Re: Contract N62470-95-D-6007  
Navy CLEAN, District III  
Contract Task Order (CTO) 0271  
U.S. Naval Activity Puerto Rico (NAPR), Ceiba, PR  
RCRA/HSWA Permit No. PR2170027203  
Correction to the Additional Data Collection Work Plan  
for SWMUs 1 and 2 dated September 9, 2004

**ATTACHMENT 1**  
**NAVY RESPONSES TO EPA COMMENTS DATED AUGUST 20, 2004**  
**ON THE ADDITIONAL DATA COLLECTION EFFORT WORK PLAN FOR**  
**SWMUs 1 AND 2 DATED JULY 23, 2004**

NAVY RESPONSE TO EPA COMMENTS DATED AUGUST 20, 2004 ON THE  
ADDITIONAL DATA COLLECTION EFFORT WORK PLAN  
FOR SWMUs 1 AND 2 DATED JULY 23, 2004

BOOZ ALLEN & HAMILTON INC.  
TECHNICAL REVIEW OF THE ADDITIONAL, DATA COLLECTION  
EFFORT WORK PLAN FOR SWMU 1 AND 2

**FIGURE 1**  
**PROPOSED SOIL SAMPLING LOCATIONS**  
**SWMU 1 – ARMY CREMATOR DISPOSAL SITE**  
**NAVAL ACTIVITY PUERTO RICO**  
**CEIBA, PUERTO RICO**

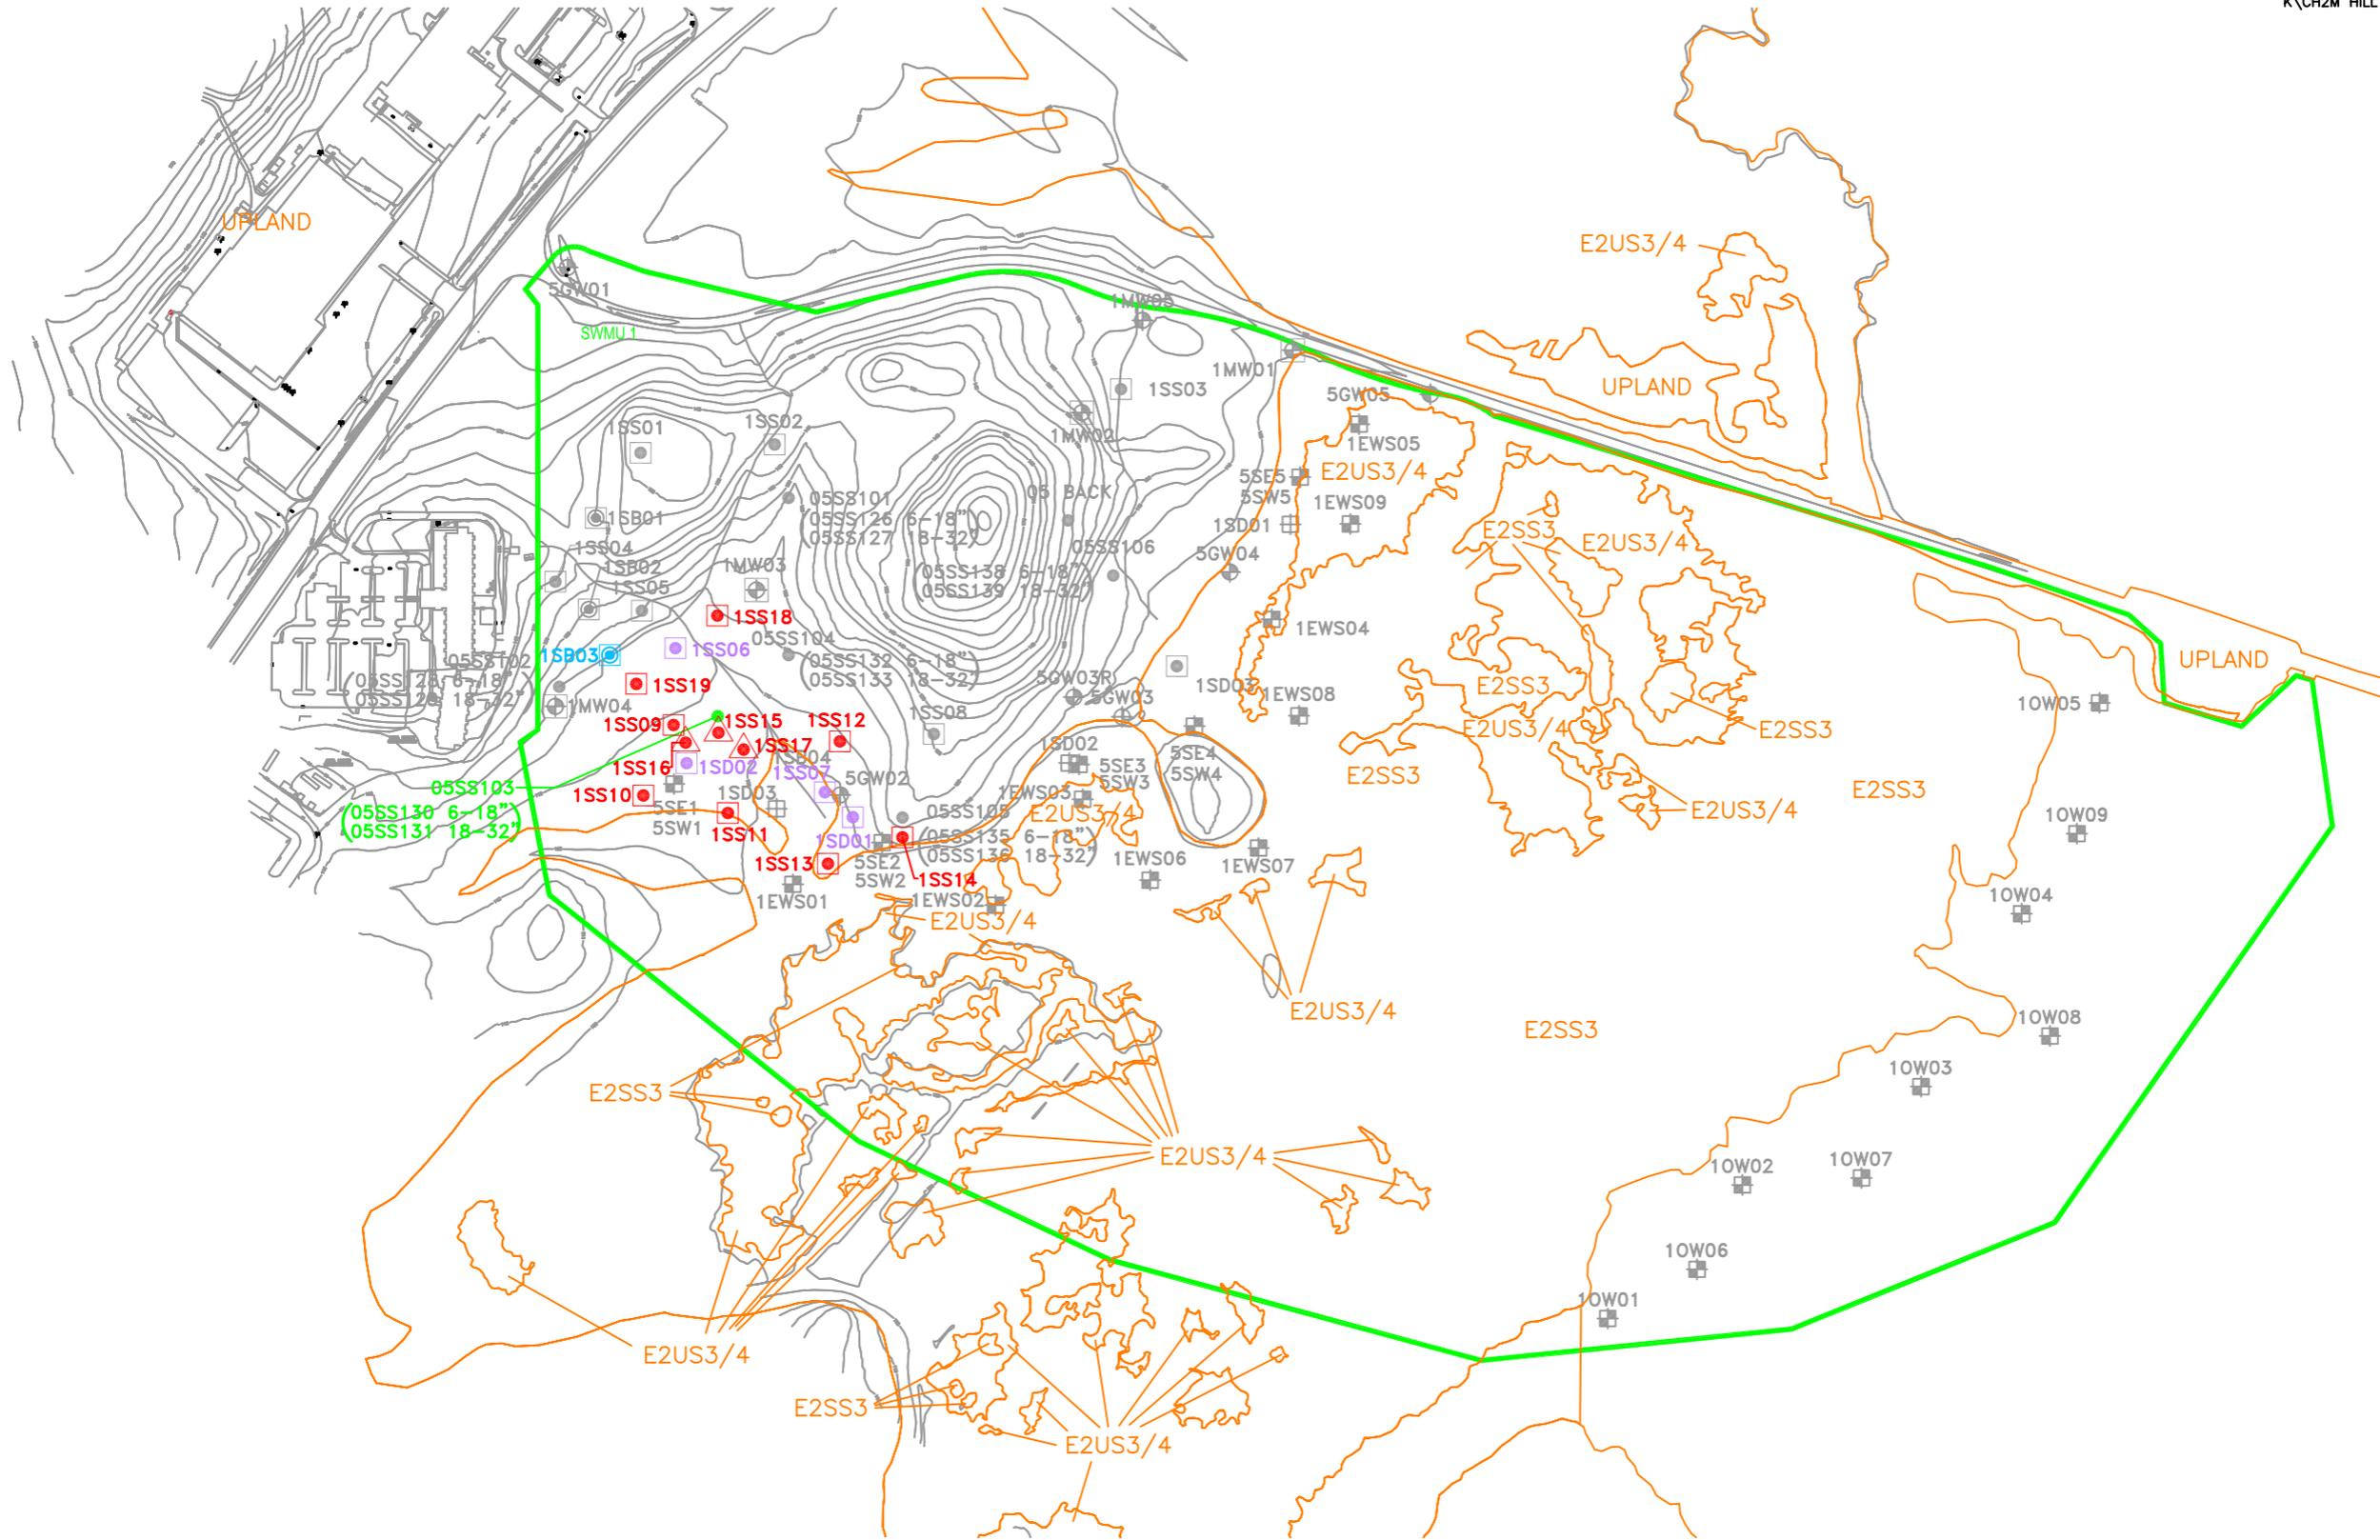
2. Historical and proposed sampling locations will contribute to delineation of pesticide contamination in soil around sample locations 1SS06 and 1SS03. However, even after the proposed investigation is implemented, no information will be available to delineate the extent of pesticide contamination west of sample location 1 SS06. At least one additional pesticide sample should be collected along the edge of the SWMU boundary in this location.

3. Historical data show higher levels of 4,4'-DDT in subsurface soil (1 - 2 feet below ground surface [bgs]) than recorded for surface soil (0 - 1 ft bgs) at SWMU 1 (sampling location 05SS103). In fact, surface soil samples frequently indicated nondetected concentrations for this pesticide. To ensure that the highest contaminant concentrations are captured during the proposed investigation, pesticide sample locations currently proposed for surface soil sampling only should be changed to include both surface and subsurface soil sampling, particularly in the southwestern corner of SWMU 1.

***Navy Response:*** *The Navy disagrees with this comment. As evidenced by Figure 1 of the additional data collection effort work plan for SWMUs 1 and 2, three surface soil samples (1SS04, 1SS05, and 1SB02) were collected upgradient (northwest) of 1SB03 during the 1996 RFI field investigation. One additional surface soil sample (1MW04) and one subsurface soil sample (05SS128) also were collected southwest of 1SB03 during the 1996 RFI and 1992 Supplemental Investigation respectively. Detected pesticide concentrations in these five samples are listed in the table below.*

*Based on the locations of 1SS04, 1SS05, 1SB02, 1MW04, and 05SS128 relative to 1SB03 (especially 1SS04, 1SS05, and 1SB02, which are located upgradient from 1SB03), as well as the pesticide concentrations reported for these five samples (see table above) the Navy does not believe additional sampling west of 1SB03 is warranted. As such, the Navy believes that further action related to this comment is not necessary.*

***Navy Response:*** *The Navy agrees with this comment and offers the following point of clarification. Proposed surface/subsurface soil sample locations 1SS15, 1SS16, and 1SS17 were placed incorrectly on Figure 1 of the Work Plan. It was the Navy's intention to depict their locations downgradient from 05SS103, not 05SS101. Figure 1 of the Work Plan will be revised to show the intended locations of 1SS15, 1SS16, and 1SS17. Beyond revision of the figure, the Navy believes that further action related to this comment is not necessary.*
